PHILCO RADIO & TELEVISION CORP.

MODELS 40-130,
40-135, 40-170CS
MODEL 40-140, 40-145
MODEL 40-160

SCHEMATIC DIAGRAM MODEL 40-160

PRODUCTION CHANGES

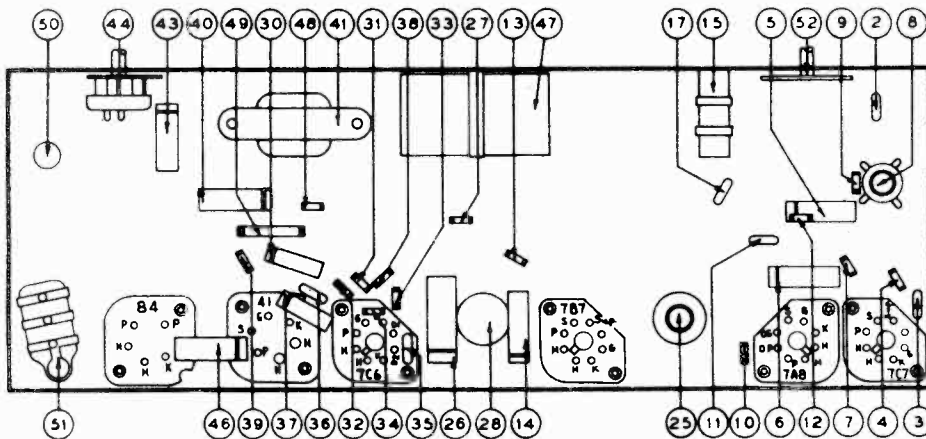
Run 3—To prevent oscillation on push-button tuning, resistors (9) Part No. 33-268339 were removed from R. F. transformer (9) secondary. A new resistor Part No. 33-260339 is now added across primary winding of the same transformer.

To prevent oscillation at the low end of the broadcast band and 2nd I. F. transformer (21) changed from Part No. 32-3281 to Part No. 32-3382.

Dial Scale changed from Model 40-140 Part No. 27-5507 to Part No. 27-5552.
Tone Control (27) changed from Part No. 42-1496 to 33-5353.
Dial Scale changed from Model 40-145 Part No. 27-5507 to Part No. 27-5552.
Tone Control (27) changed from Part No. 42-1496 to 33-5353.
MODELS 40-140, 40-145, 60 Cycle Current
Operating on 115 V. A.C., 60 Cycle Current
32-8064, 115 volts, 60 cycle current in the Service Bulletin, must be changed to Part No. 32-8073, 115 volts, 25 cycle current. Electronic Condenser (49) Part No. 30-2409, 12 mfd., 400 volts must be changed to Part No. 32-8064, 115 volts, 60 cycle current by changing the power transformer (52).
Service Bulletin 328, from Part No. 32-8064, 115 volts, 60 cycle to Part No. 32-8098, 220 volts, 60 cycle, connecting the primary wiring as listed below.
Power Supply: 220 Volts—Red and Yellow to White.
Connect together: 220 Volts—Black and White to Red.
Part No. 32-3281 to Part No. 32-3382.
